STAFF REPORT
KETCHUM PLANNING AND ZONING COMMISSION
MEETING OF APRIL 23rd, 2024

PROJECT: Warm Springs Preserve Building

FILE NUMBER: P23-104

APPLICATION: Design Review

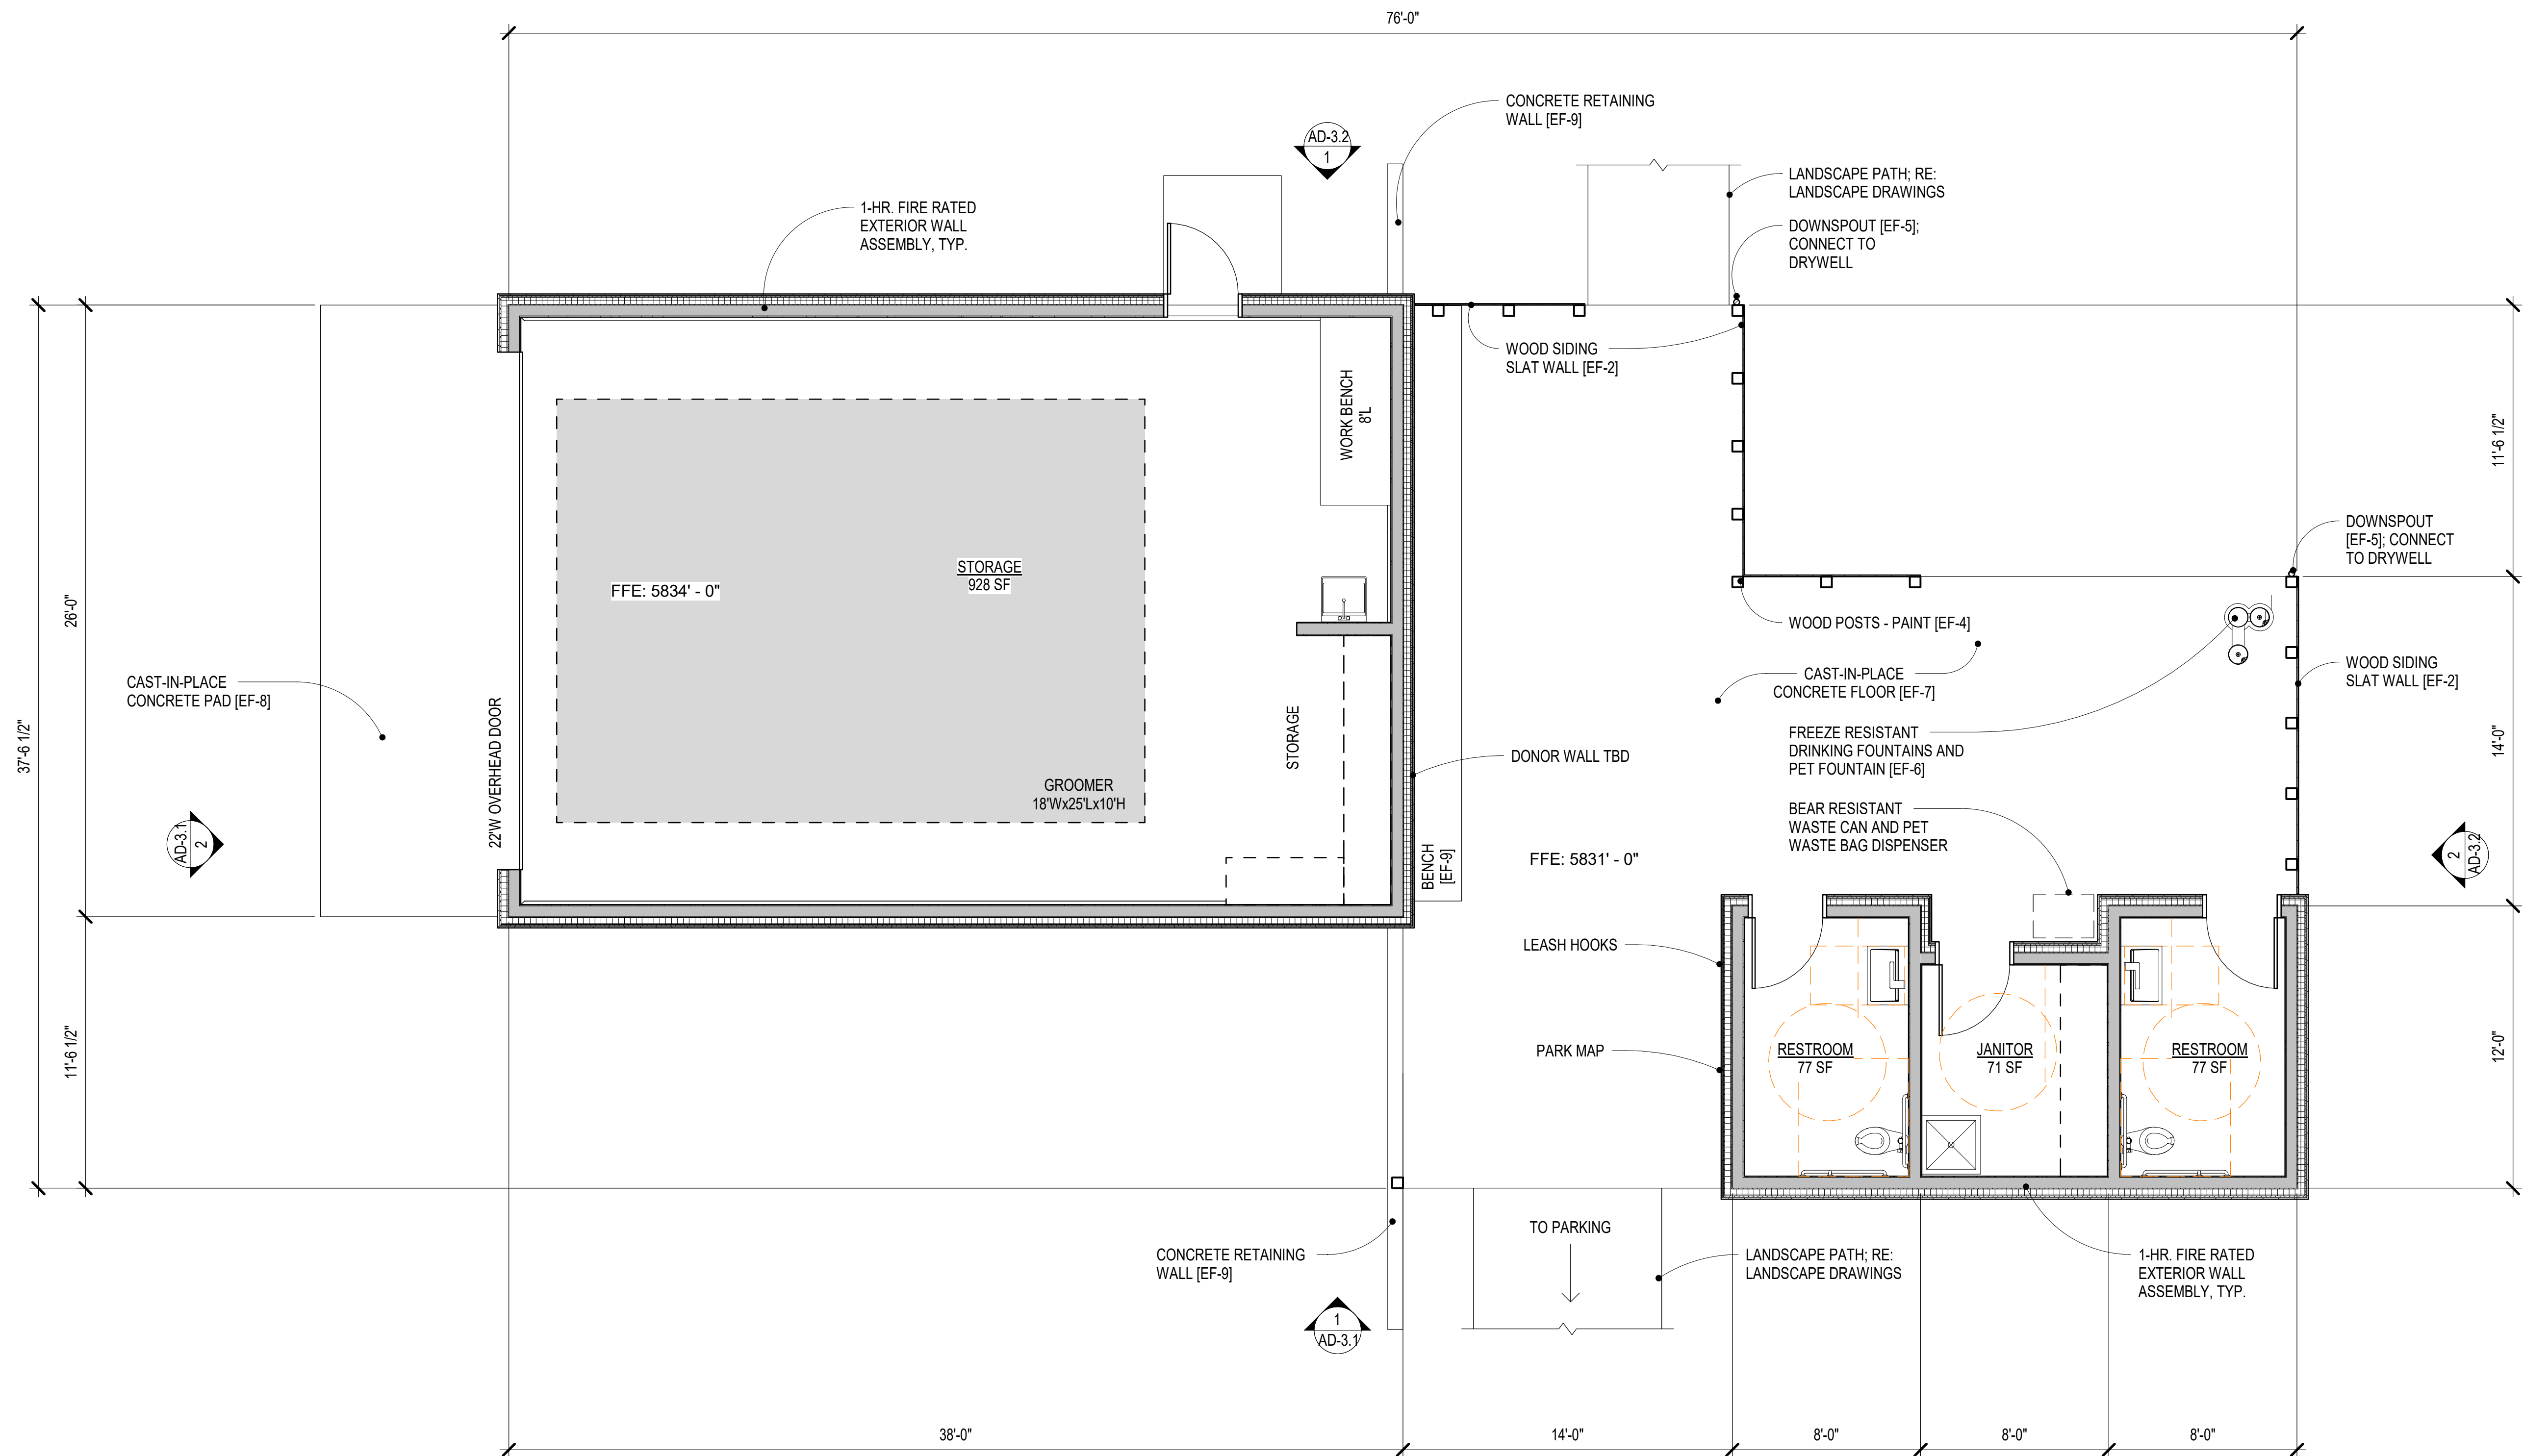
| 17.96.060.I.1 – Landscaping | Conformance |
|--|-------------|
| Finding: Landscaping has been provided for the project as indicated on Sheet L2.00. | |

| 17.96.060.I.2 – Landscaping | Conformance |
|---|-------------|
| Finding: The landscape plan for the project proposes primarily species which are native to the area. These species are readily adaptable to the microclimate as many are present naturally within the Warm Springs Preserve. | |

| 17.96.060.I.3 – Landscaping | Conformance |
|--|-------------|
| Finding: The landscape plan for the project proposes drought-tolerant and native species, including douglas fir, aspens, native shrubs, and drought tolerant grasses. | |
